寄件者: [REDACTED]
寄件日期: 2025年10月15日星期三 11:04
收件者: tpbpd/PLAND
副本: [REDACTED]
主旨: Fw: S. 16 Planning Application No. A/YL-KTN/1113 - Departmental Comments
附件: Drainage Proposal-R1.pdf

Response to Comment Table

Application No. A/YL-KTN/1113
Lots 949 (Part) and 1103 (Part) in D.D. 107,
Kam Tin North, Yuen Long, New
Territories

Drainage Proposal

Figure 4.2 – Proposed Layout of the Drainage Channel for the Project Site

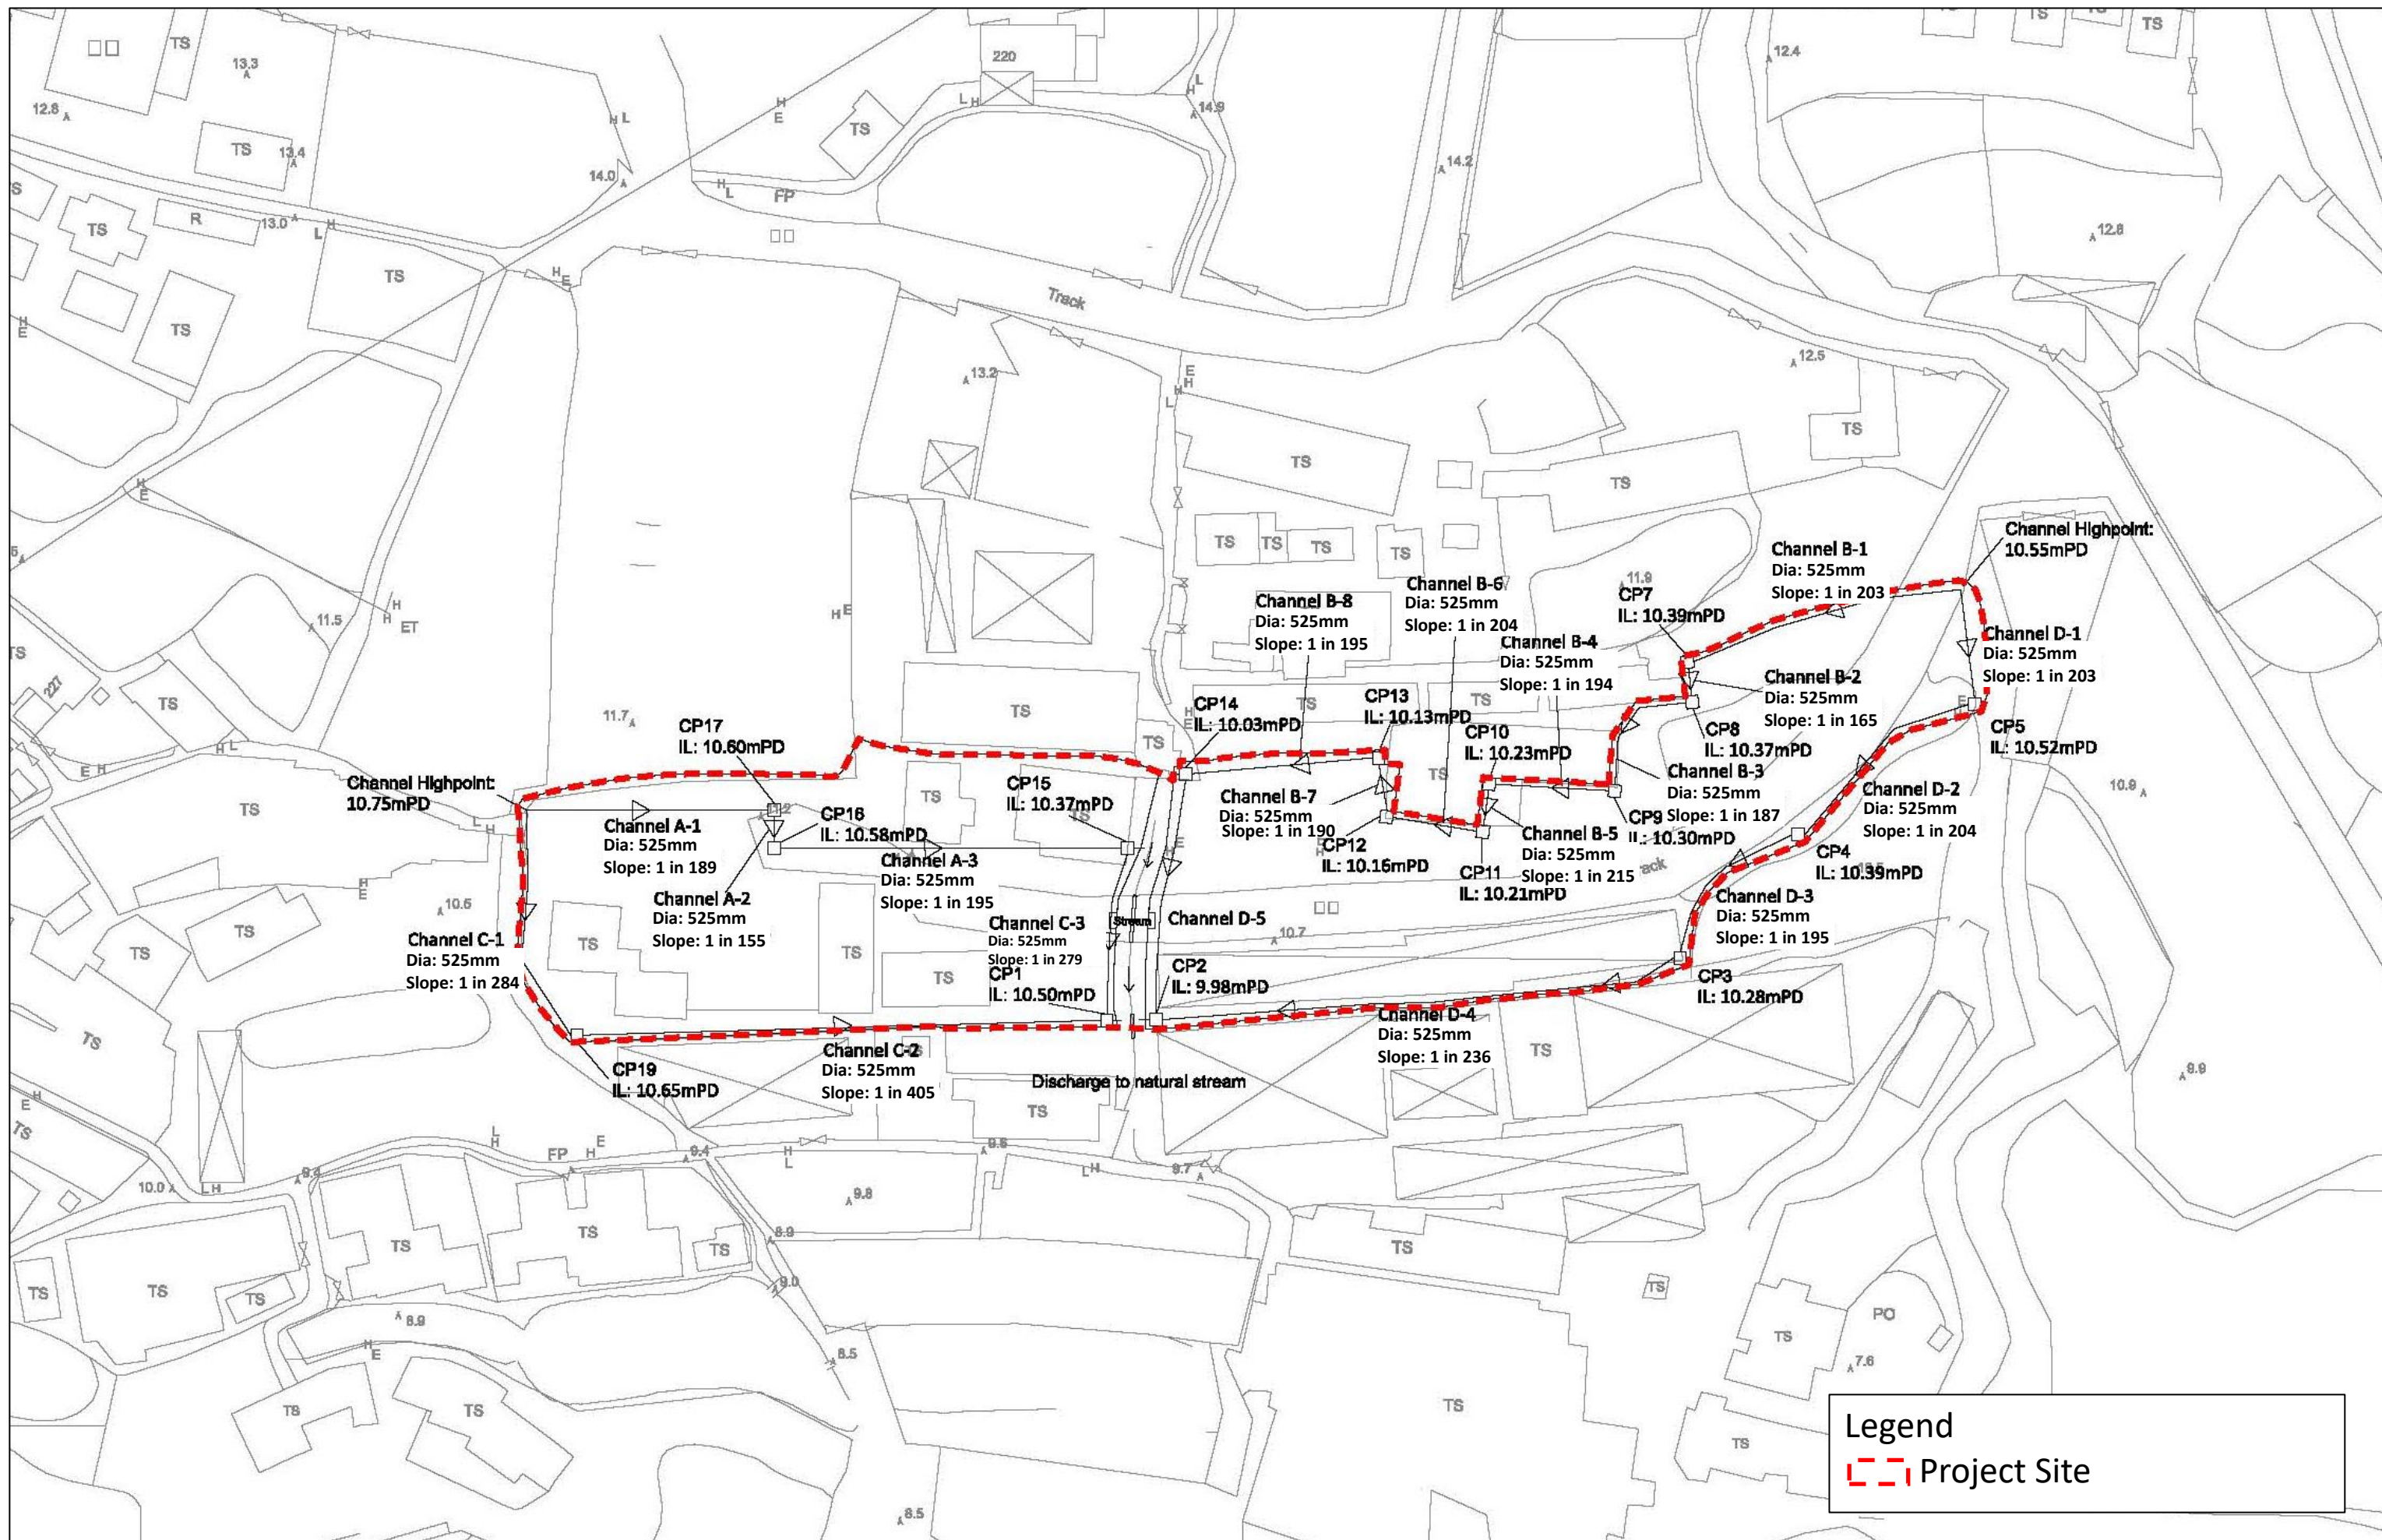
Comments from Drainage Services Department (Contact Person: Ms. Jessica KWAN; Tel.: 2300 1444) I have the following comments on the submitted drainage proposal: (1) Para. 3.2.3 - "Ng Tung River" and the quoted channel feature no. are not applicable to this submission. (2) A simple table in the main text should be added to compare the runoff generated by different catchments before and after the proposed development. (3) As mentioned in para. 4.3.2, the stormwater will enter the Project Site through the section where no concrete footing is provided at the hoardings. However, majority of the site will be filled to about 11.0 - 11.2mPD as shown in Figure 4.1. Please advise (with illustration by cross-sections) how the surface runoff from the adjoining area could still be collected properly by the proposed drainage system. For Figure 2.5, please clarify the extent of the hoarding with and without concrete footing and if it will be modified under the proposed development. (4) It is noted that the natural stream within the site is heavily vegetated. Please carry out routine vegetation clearance to maintain its hydraulic capacity.	Noted. The irrelevant channels are removed. Noted. Table 4.1 has been added accordingly. Noted. Section 4.1.2 has been revised to further elaborate how the filling works would not affect the surface runoff path from the adjoining area entering the Project Site after the proposed development. Figure 2.4c has been added to demonstrate the level of the Project Site after the filling works. A markup has been added to Figure 2.5 to show the extend of fence without a permeable footing. Noted. Project proponent will be responsible for regular clearance of vegetations. Section 4.4.3 has been added to confirm.

- 4.3.7 **Figure 4.2** shows the proposed layout of the drainage channel for the Project Site. Technical details of the proposed drainage channel, including the type, dimensions, invert levels are given in **Table 4.2**. The technical details of the proposed upgrade of the natural stream are given in **Table 4.3**. Detailed calculations are given in **Appendix 4.1** to **Appendix 4.4**. As the Project Site is located within Kam Tin North district. According to Figure 3 Delineation of Rainfall Zones of the Manual, the area is outside the 3 specific areas: Tai Mo Shan Area, West Lantau Area, North District Area. As such Storm Constants for rainfall statistics of HKO Headquarters is used in the calculation. The design drainage system is to handle stormwater of Return Period of 50 years.

- 4.4.3 The Applicant shall rectify the system if it is found to be inadequate or ineffective during operation at his / her own expense, in addition to those within the Project Site. Regular maintenance includes clearance of vegetation growing within the stream at the centre of the Project Site.
